# Memorandum

**RE:** **Downtown Chesterfield, (Categories A&B) ASDCP Power of Review:** An Amended Site Development Concept Plan, Landscape Concept Plan, Signage Concept Plan, and Lighting Fixture Concept Plan for the 78.4 acre tract of land located south of Wild Horse Creek Road, west of Chesterfield Parkway, and north and east of Burkhardt Place.

## Planning Commission Staff Report

DRAWN BY: A.C.D.	CHECKED BY: G.M.S.
DATE: 09/15/2020	JOB NO: 219-6670
K.S.P. # 20MSD-00335	DATE PLOTTED: 185/181
S.L.C. HWT #	HWT S.L.P. #
M.D.N.R. # MORA16776	
SHEET TITLE: <b>SITE DEVELOPMENT CONCEPT PLAN</b>	
SHEET NO.: <b>C3.0</b>

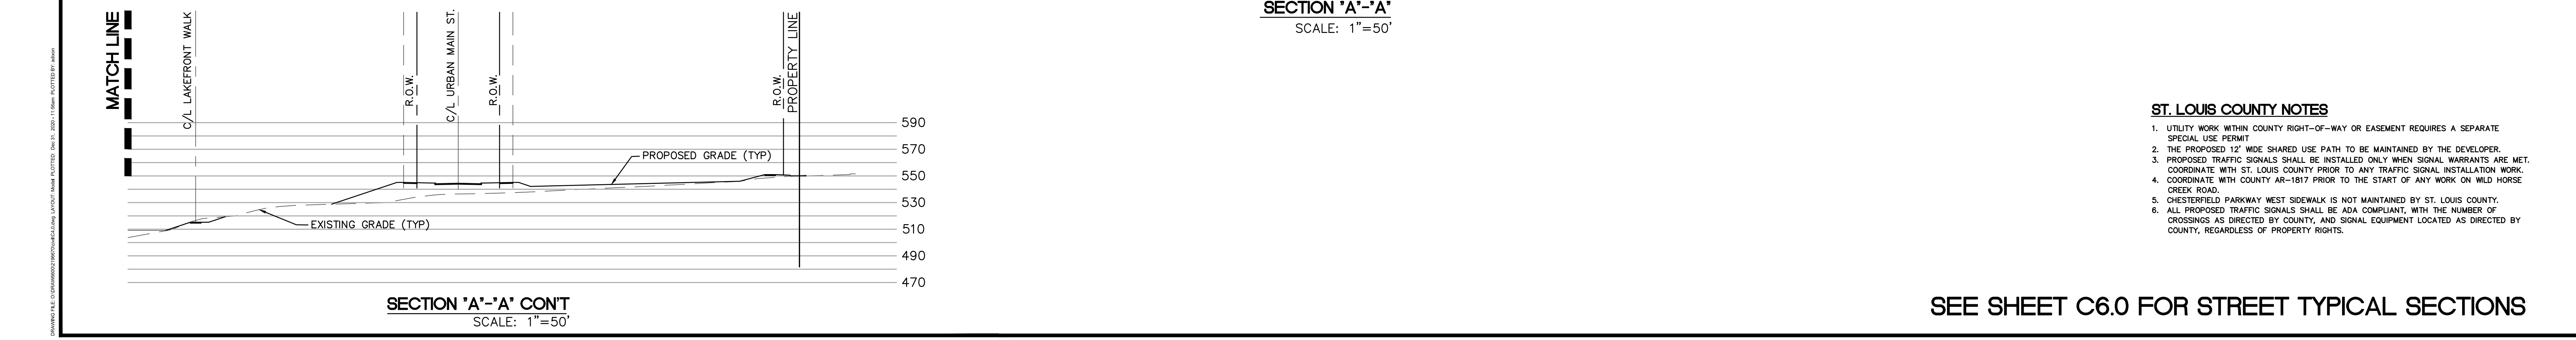
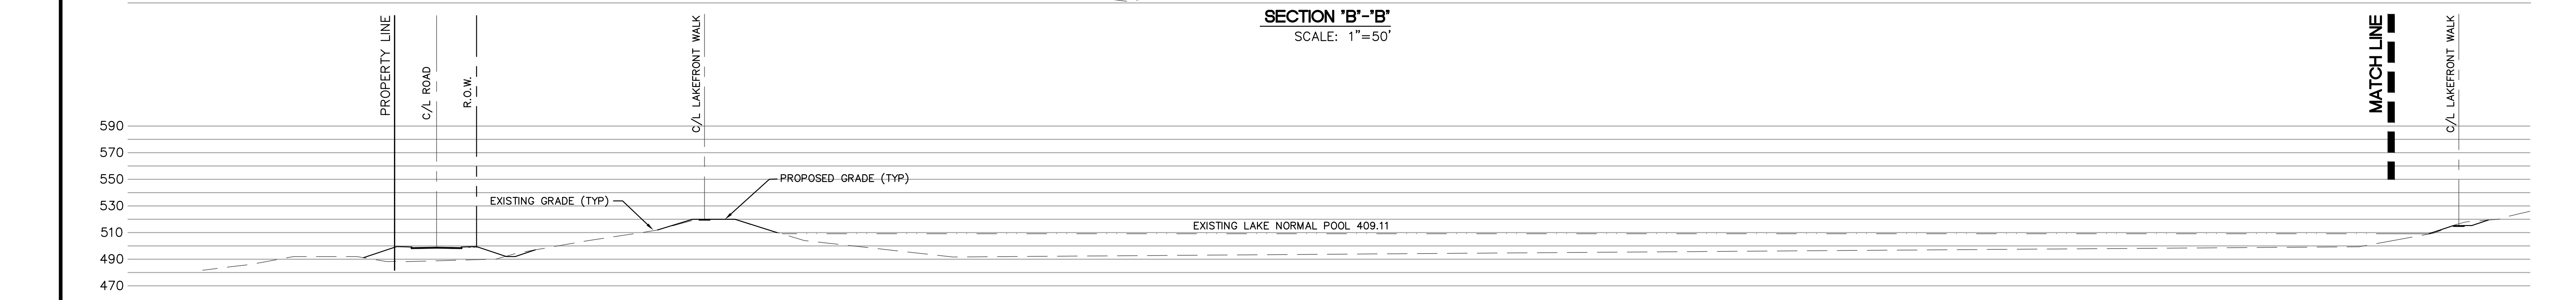
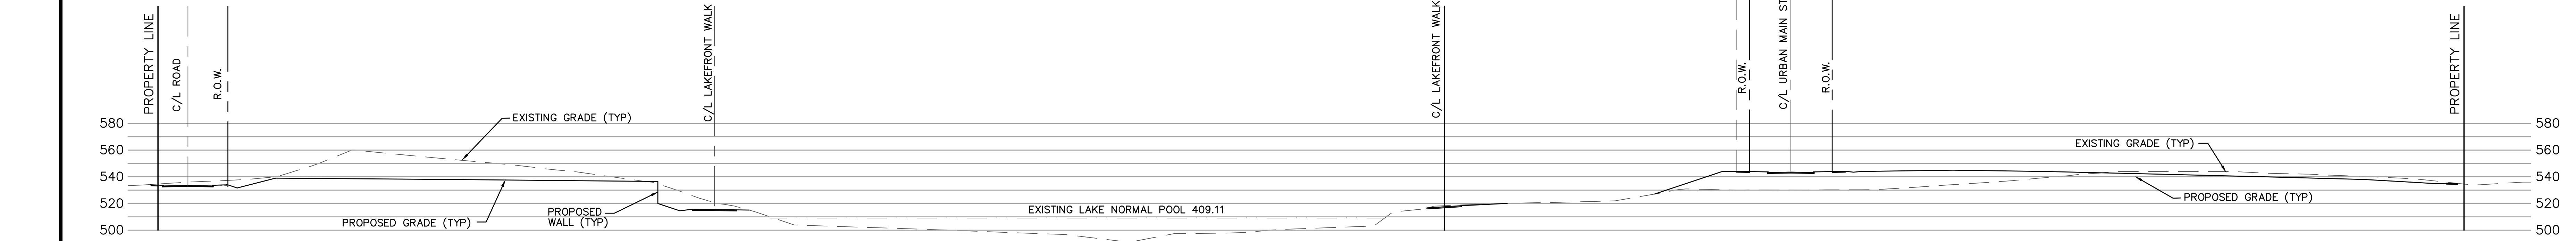
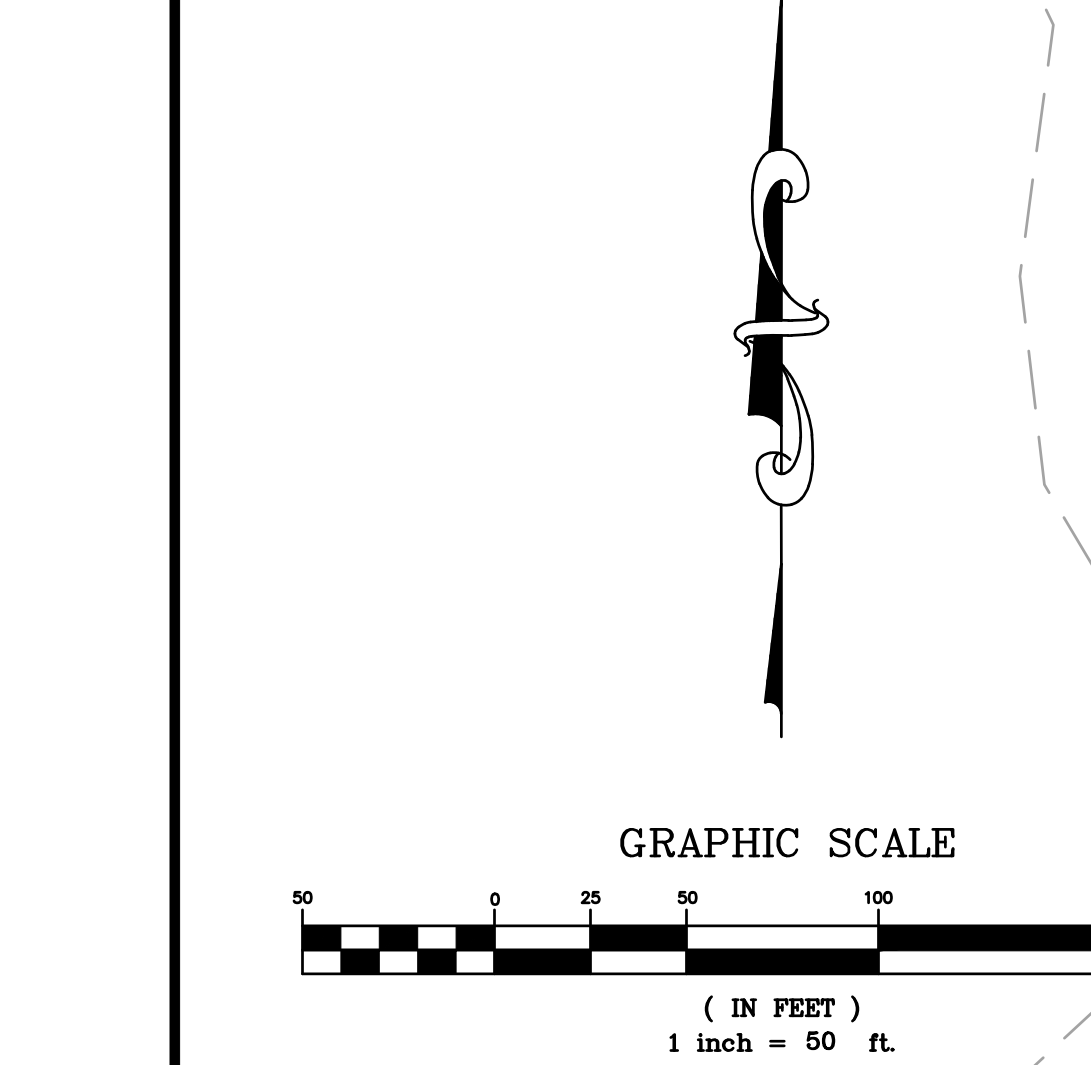
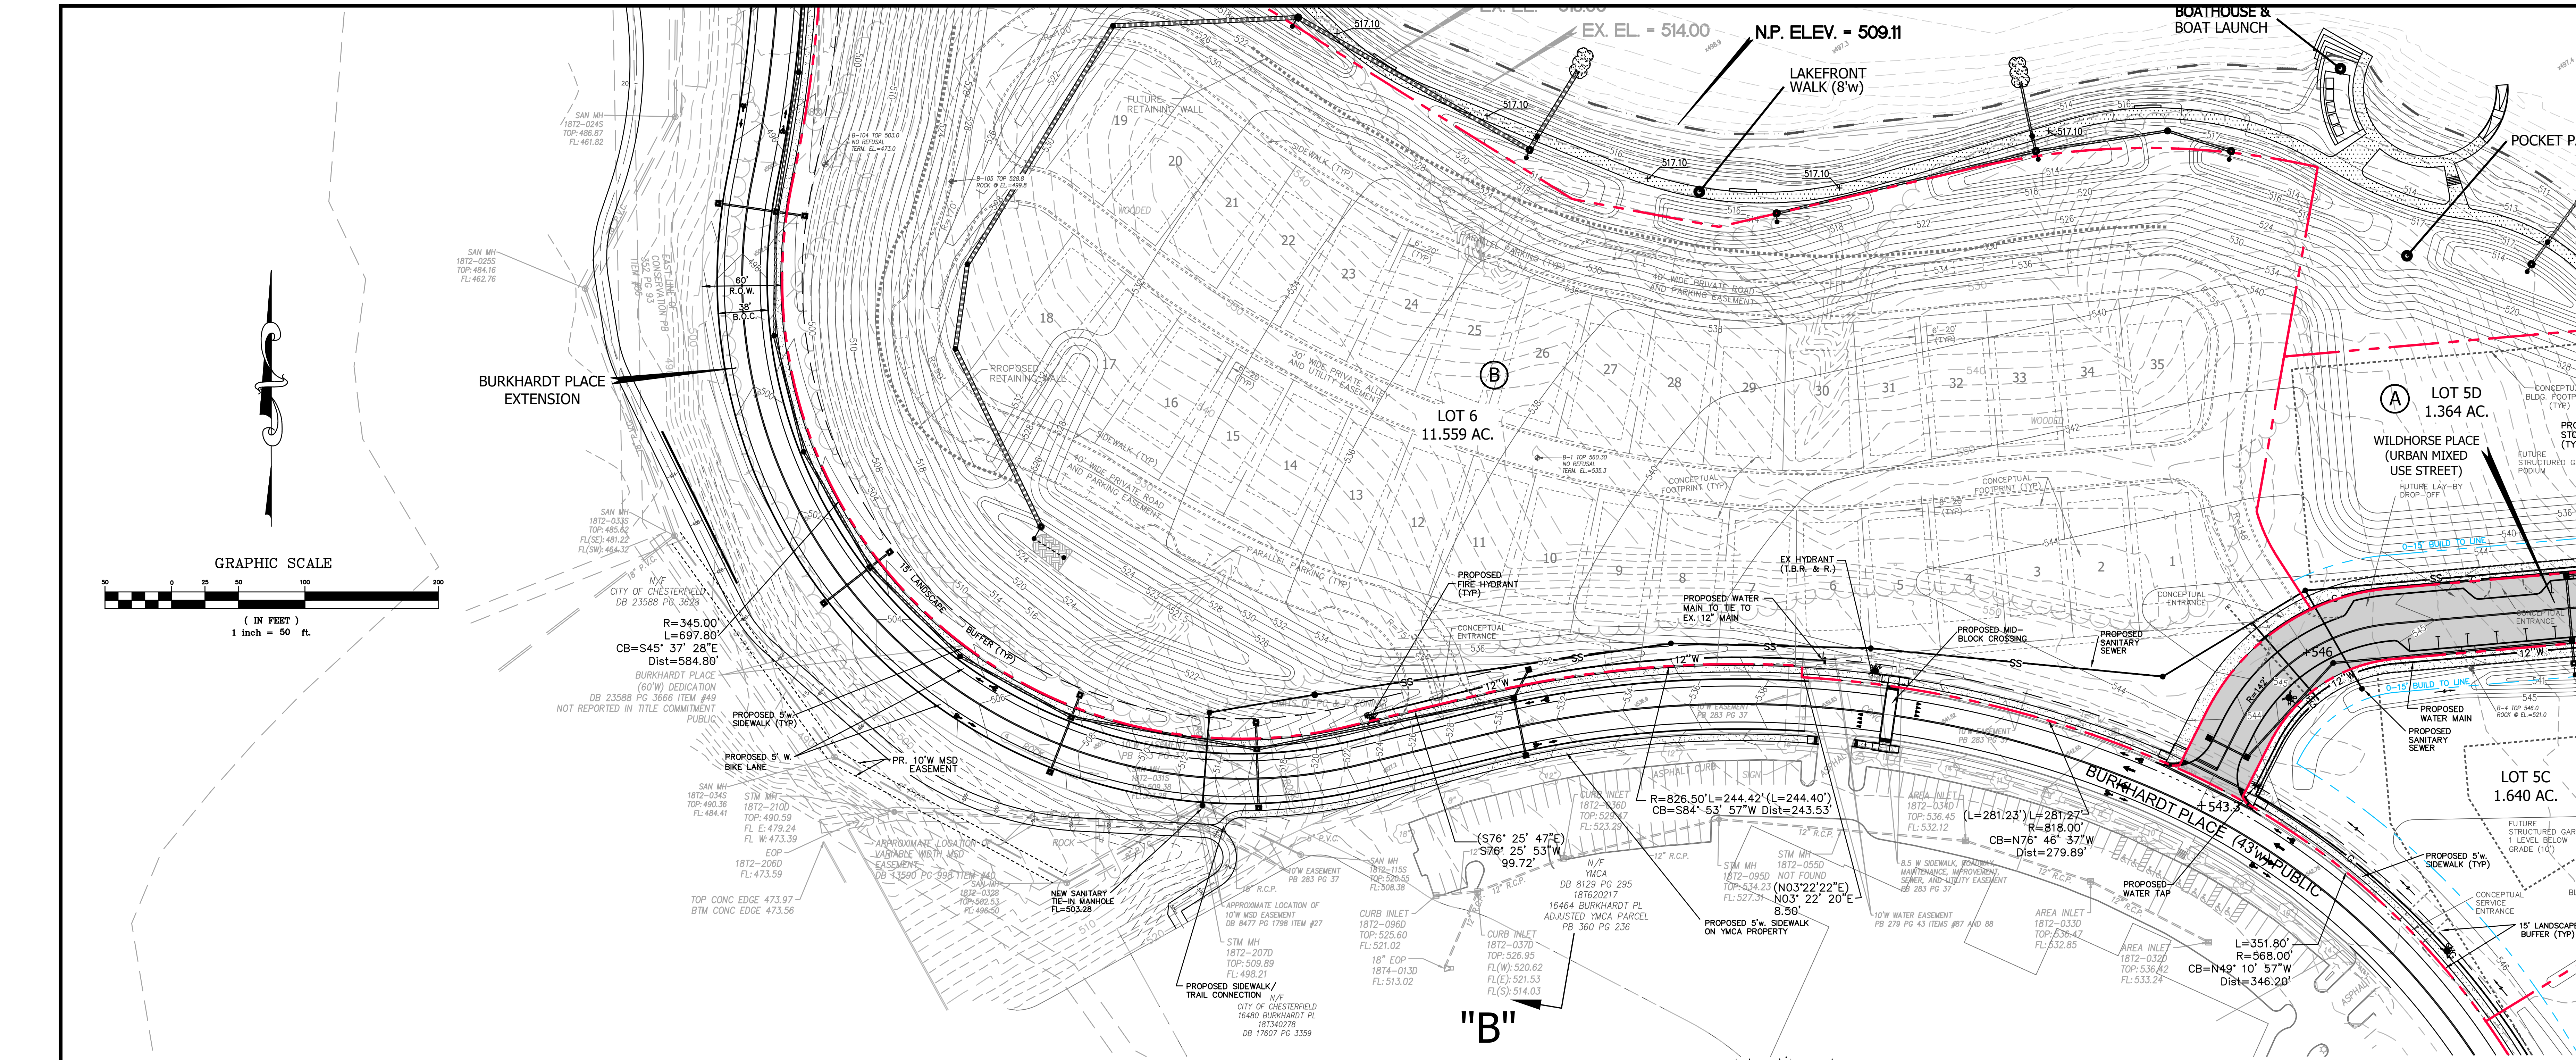
3. There was an abundance of discussion on deliveries for Wildhorse Village within the zoning process. As staff reviews the ASDCP, each access point/entry to each individual lot on roadways has been reviewed against access management principles within the City's UDC similar to comment 1. There is still a bit of ambiguity that remains on the overall strategy of commercial and residential delivery and loading. Provide a narrative on this strategy and at what point in the development process the final configuration will be defined. This narrative will be provided in the Planning Commission packets.

We appreciate the City and Planning Commission's focus on the overall strategy of service (refuse, loading, & deliveries) within the development. For the ASDCP, we have revised the Conceptual Service Entrances to adhere to the City's UDC and Development's Ordinance #3114. We have focused on placing service entrances that could be shared with multiple tenants / parcels while be screened by future buildings and plantings. Final service configurations for individual lots will be approved at the Site Development Section Plan.
